RESPONSES TO ALUC COMMENT LETTER

The Solano County Airport Land Use Commission (ALUC) submitted comments on SMUD’s “Proposed Decision and Findings that the Solano 4 Project Is Consistent with the State Aeronautics Act” (Findings). Pursuant to State Aeronautics Act (Act) Section 21676,¹ ALUC’s comments are only “advisory” and, regardless, are meritless. Among other things, ALUC’s interpretation of the relevant statutes is largely unsupported citations to legal authority. Although not necessary, further explanation is provided below and in the attached letter from Westslope Consulting (August 18, 2021): “Solano County Airport Land Use Commission’s Response to SMUD’s Proposed Overrule Findings.”

Re: Solano County Airport Land Use Commission's Response to SMUD's Proposed Overrule Findings

Figure 1

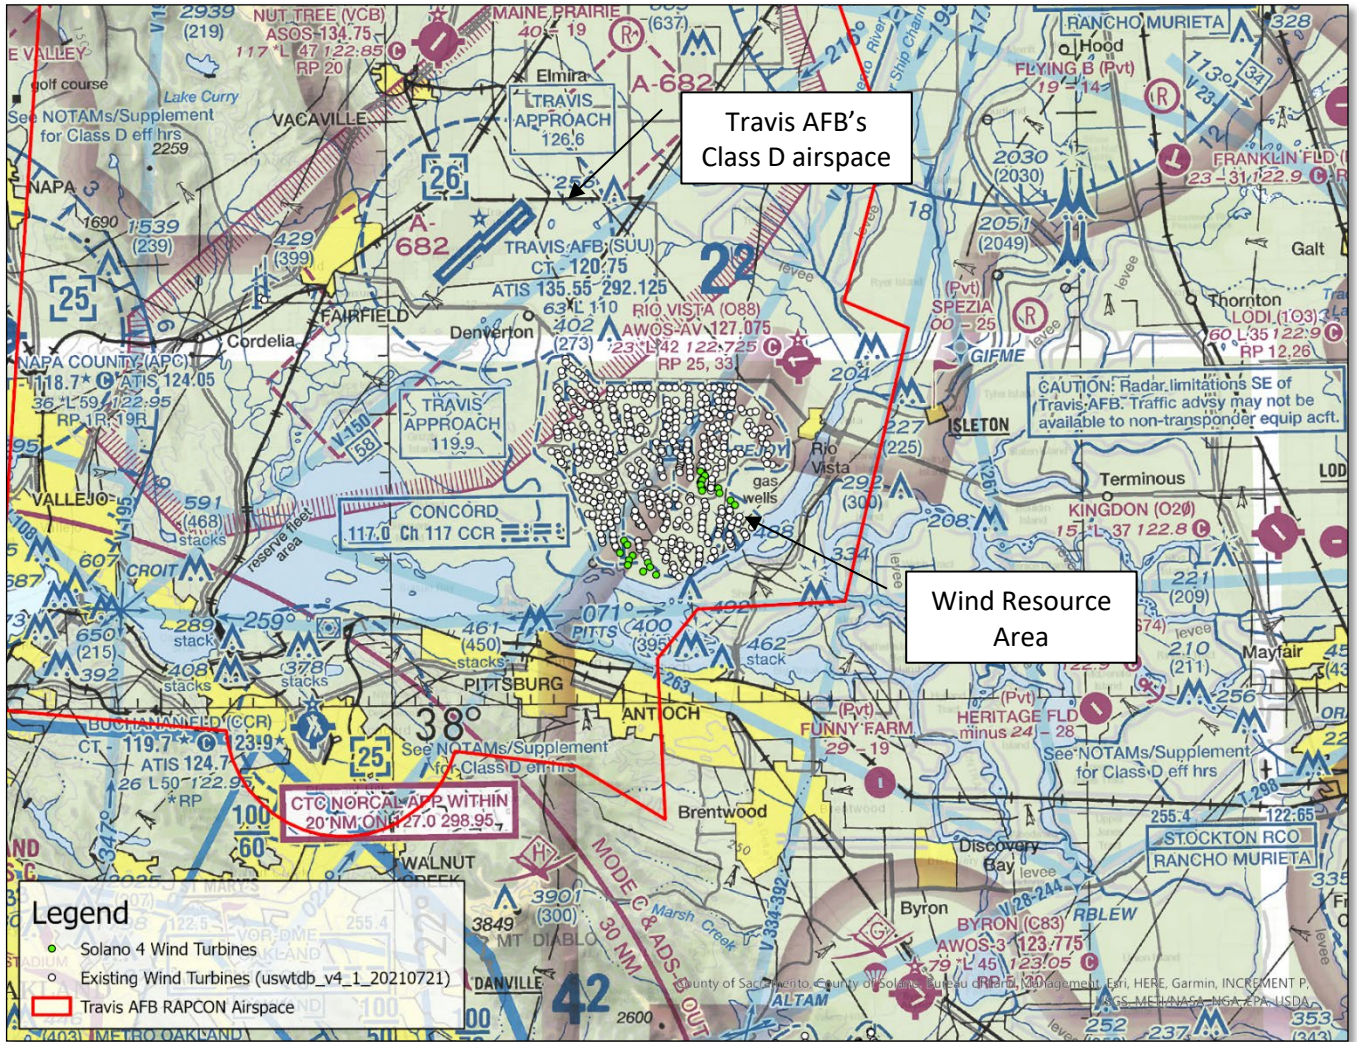
The ALUC goes on to state that "[t]here is no discussion regarding radar, and one can only guess that SMUD concludes there will be no negative effects because the planes will be picked up by the MSSR radar, as they will have transponders. While transponders are required for commercial aircraft, most private civilian planes are not required to, nor do they in fact have, transponders if they are flying under visual flight rules and below 10,000 feet in the airspace classified as D (within five miles of Travis AFB) or E. (14 CFR § 91.215.)" and "[t]he inability for Travis AFB air traffic controllers to see even a portion of them at any given time is a safety concern that appears to remain unmitigated."

also important to note that the Project as well as the entire Wind Resource Area is outside of Travis AFB's Class D airspace. See Figure 1, where the blue dashed line around Travis AFB represents the Class D airspace and the green dots represent the Project. Even though a transponder is not required within Class D airspace, aircraft operating in or transiting the Class D airspace must be in radio contact with Travis AFB in accordance with 14 CFR § 91.129. Aircraft operating over the Wind Resource Area below 10,000 feet above mean seal level, which is Class E airspace, are not required to use a transponder or to be in radio contact with Travis AFB Radar Approach Control (RAPCON) facility; however, pilots must "see and avoid" other aircraft per 14 CFR § 91.113. See and avoid is an inherent part of the United States National Airspace System and is analogous to drivers avoiding other vehicles on the roads. Further, despite the ALUC's unsupported assertion to the contrary, as stated above regarding my firsthand experience, the vast majority of aircraft operating in and around the Travis AFB RAPCON's airspace do, in fact, utilize a transponder. As recently as 2017, Travis AFB encouraged pilots flying in the RAPCON's airspace to use transponders as part of its Mid Air Collision Avoidance (MACA) outreach program.¹ It should also be noted that the caution box to the east of the Wind Resource Area in Figure 1 was added as a mitigation as part of the work conducted by the first Cooperative Research and Development working group. This caution notifies pilots that Travis AFB may not be able to issue traffic advisories for aircraft that are not operating a transponder.
